From: Marge Schmuckal
To: Lee Urban
Date: Tue, Mar 9, 2004 9:04 AM
Subject: Re: Flood Plain/Ocean Gateway

From: Marge Schmuckal
To: William Needelman
Date: Thu, Jan 15, 2004 4:32 PM
Subject: Re: Fwd: Oceangateway Parking Evaluation

On May 25, 2004, the Portland Planning Board voted unanimously to approve the following motions regarding the Ocean Gateway Marine Passenger Terminal:

FLOOD MAP

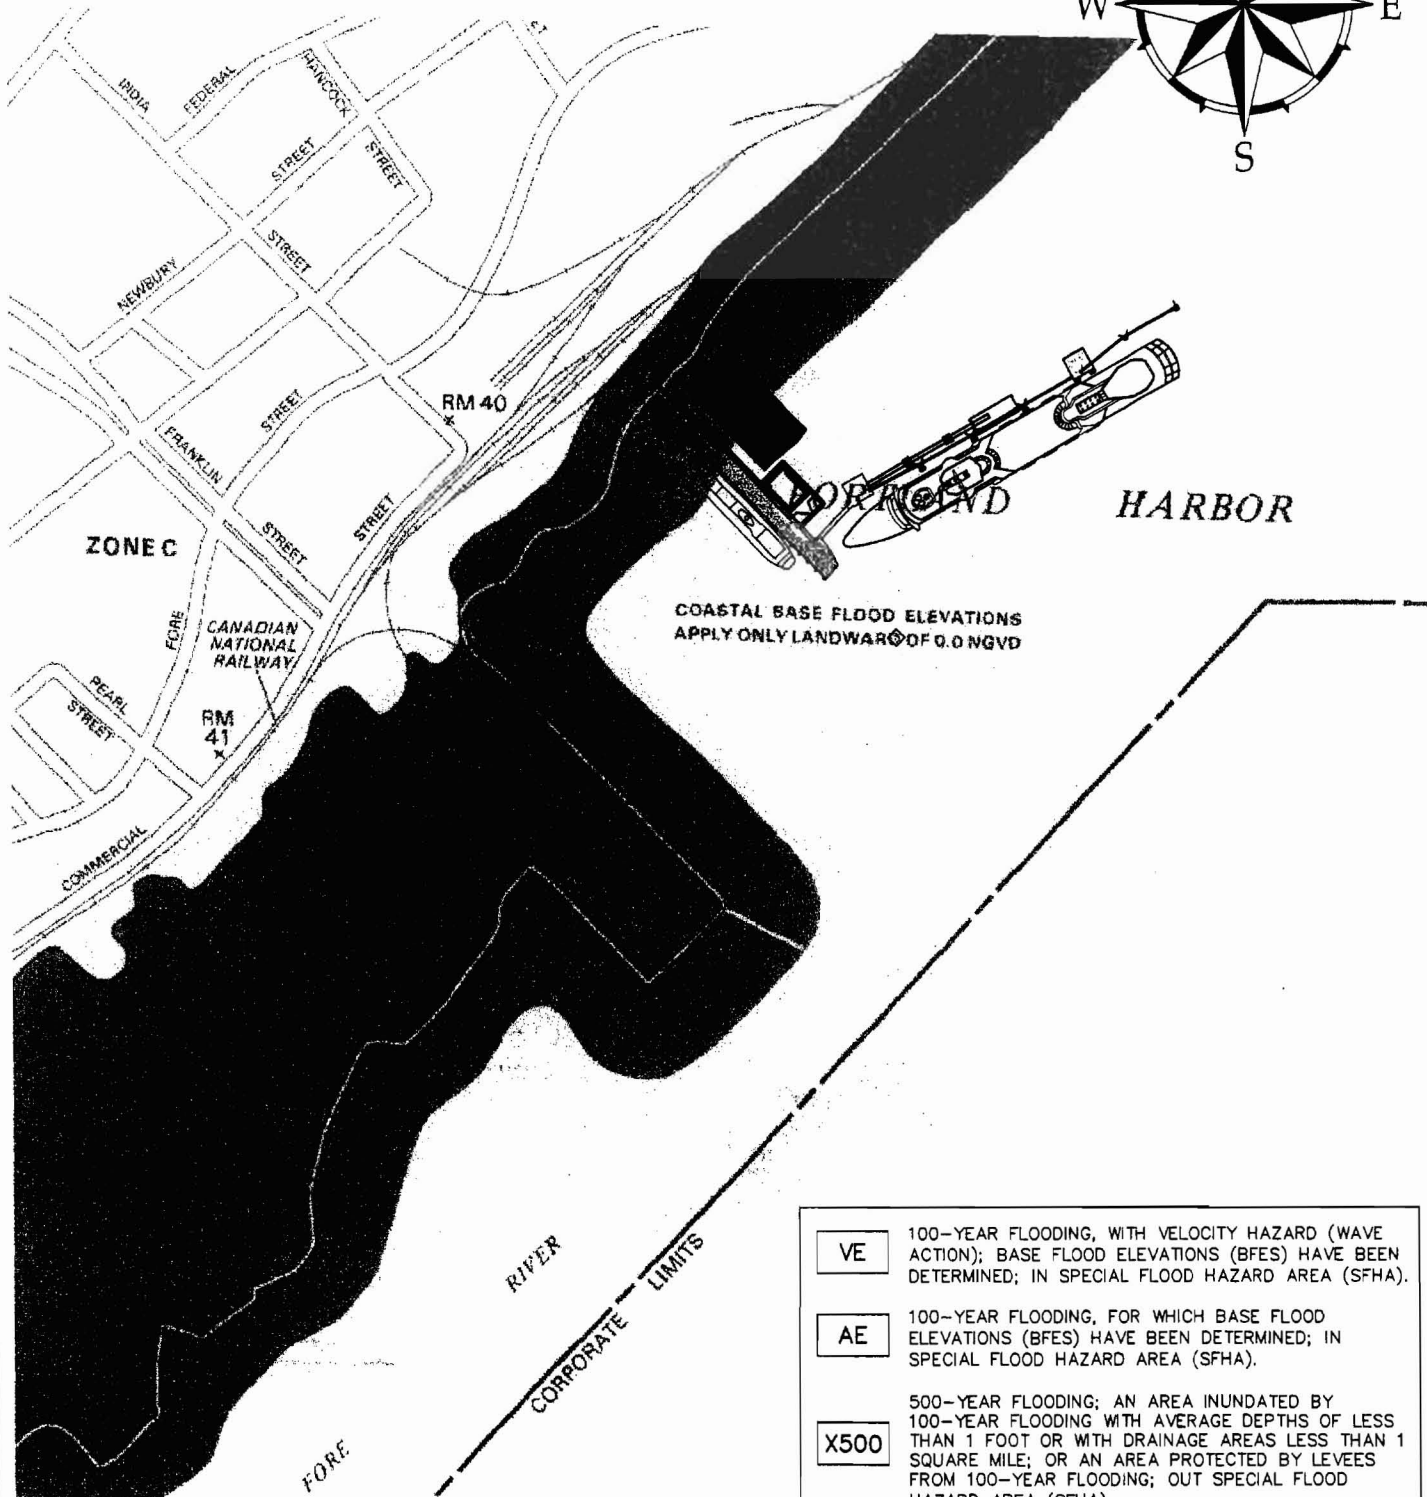
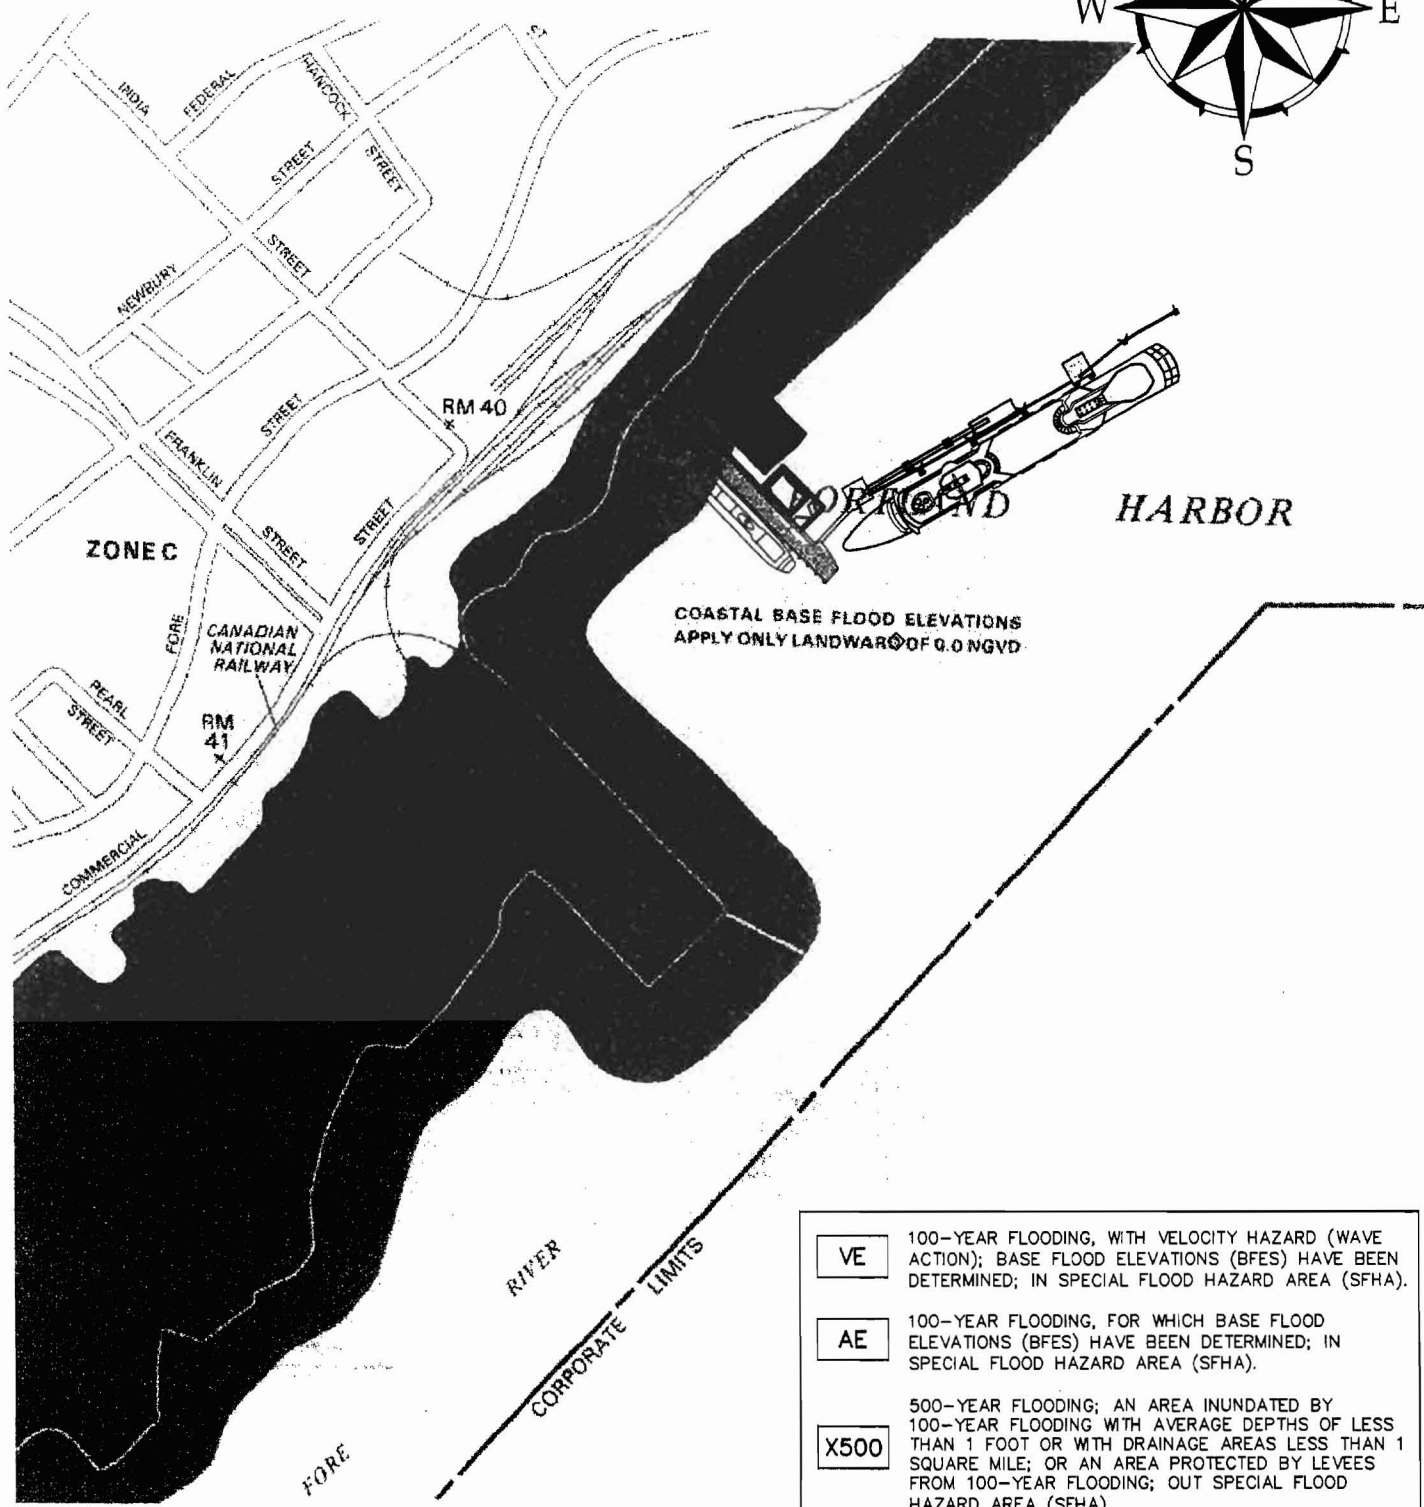
As the existing Pier 2 is not depicted on the FIRM, W&C superimposed the pier onto the FIRM (see Figure 2) and found the southern half of the existing pier located seaward of the mapped flood hazard zones, not within any mapped zone. Without a mapped zone, for W&C to assess and determine the project site flood elevation, we look to FEMA's methodology, the findings of the Flood Insurance Study, and the mapping on the surrounding area. The A2 flood zone on the site and abutting areas overlay onto all of the existing piers in Portland (on the Fore River); including the Maine State Pier, the abutting Galt Wharf and those wharves and piers extending up the Fore River to Union Wharf and ultimately to the International Marine Terminal, refer to Figure 1. The FIRM indicates flood zone boundaries (and elevations) are in part delineated by pier structures. It appears that all piers which existed along the Portland waterfront at the time of the FIRM development were placed into the A2 zone. Locations seaward of the existing piers were mapped as V2 and V3 zones, see Figure 2.
